Access Compliance Report

Public Rights-of-Way

(Curb Ramps)

Intersection ID: 46372	Main Street: ROYAL_CASTLE_CT	Cross Street: STRONVAR_HOUSE_LN	Location: E
ADA ID: A5CB4CD36092	Ramp Type: PerpDiag	Initial Pass/Fail: Fail	Overall Compliance: No
Severity Score: 46.25			
Codes/Mitigation Info/Possible Solution		Field Measurements/Component Compliance

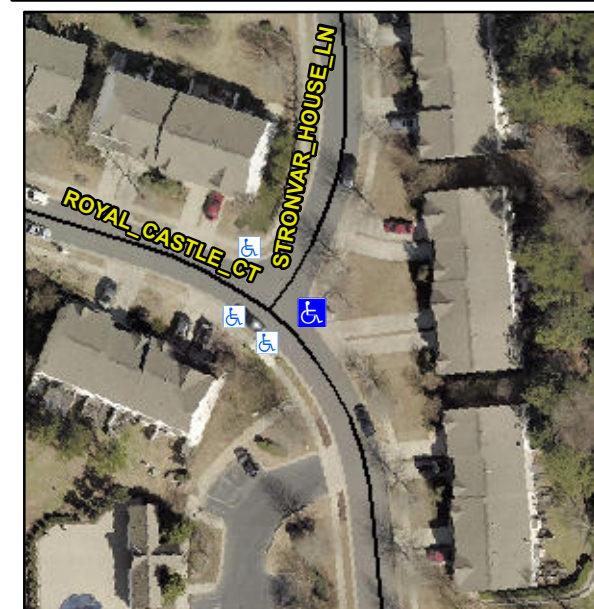
R304.5.1, R304.2.2, R304.5.3

Compliance	Description	Data	Compliance	Description	Data
N/A	Ramp Length (in)	48.0	No	Ramp Slope (%)	11.3
No	Ramp Width (in)	47.0	No	Ramp XSlope (%)	8.2
N/A	Flare Type LT	N/A	N/A	Flare Type RT	N/A
N/A	Flare Slope LT (%)	N/A	N/A	Flare Slope RT (%)	N/A
N/A	Flare Traversable LT?	N/A	N/A	Flare Traversable RT?	N/A
N/A	Landing Length (in)	N/A	N/A	DWS Provided?	N/A
N/A	Landing Width (in)	N/A	N/A	DWS Contrast?	N/A
N/A	Landing Slope (%)	N/A	N/A	DWS Length (in)	N/A
N/A	Landing X Slope (%)	N/A	N/A	DWS Full Width?	N/A
N/A	Landing Curb? (Y/N)	N/A	N/A	DWS Offset (in)	N/A
N/A	Shared Landing?	N/A			
N/A	Gutter Ponding?	N/A	N/A	Gutter Slope (%)	N/A
N/A	Gutter Lip Ht (in)	N/A	N/A	Gutter X Slope (%)	N/A
N/A	Painted X Walk1?	No	N/A	Painted X Walk2?	No
	X Walk 1 Direction	To NW		X Walk 2 Direction	To SW
N/A	X Walk 1 Width (in)	N/A	N/A	X Walk 2 Width (in)	N/A
	X Walk 1 Slope (%)	4.6		X Walk 2 Slope (%)	1.2
	X Walk 1 X Slope (%)	1.9		X Walk 2 X Slope (%)	2.6

Remove & Replace Curb Ramp With Two New Directional Ramps or Equivalent.
